P 516089

ON-SITE SEWAGE DISPOSAL SYSTEM
HOWARD COUNTY HEALTH DEPARTMENT
BUREAU OF ENVIRONMENTAL HEALTH

SUBDIVISION: Westwoods at Cherry Grove LOT NUMBER: 18

ADDRESS: 16917 Old Sawmill Road PROPERTY OWNER: D R Horton, Inc

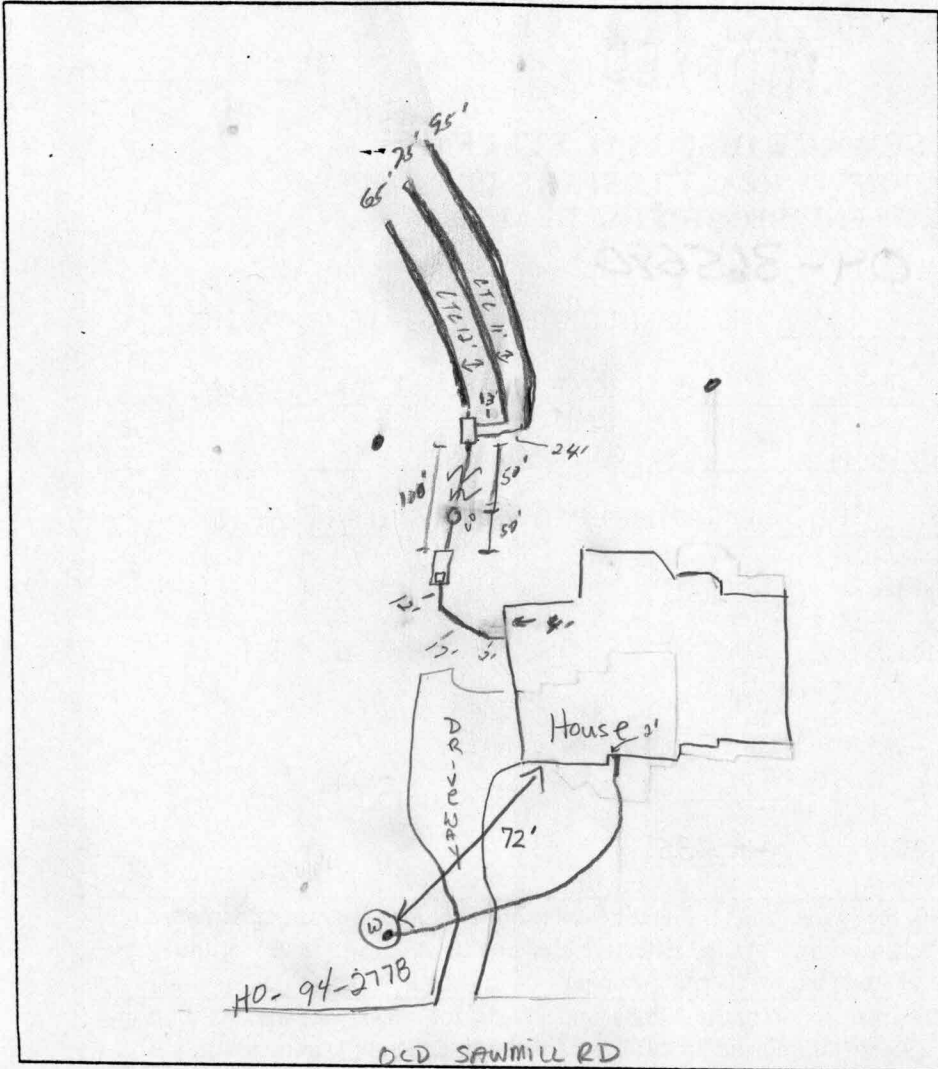
PRE-CONSTRUCTION INSPECTION: 12/18/01 OK TO START PER PLAN 12'CTC Contour close
 TO MAINTAIN STABILITY FOR PIPES TO ST., Stone will be added (due to fill). Area staked. (K6)

INSPECTION COMMENTS: 1/4/02 Stone under line from house conn. to house OK to cover all work (SC)
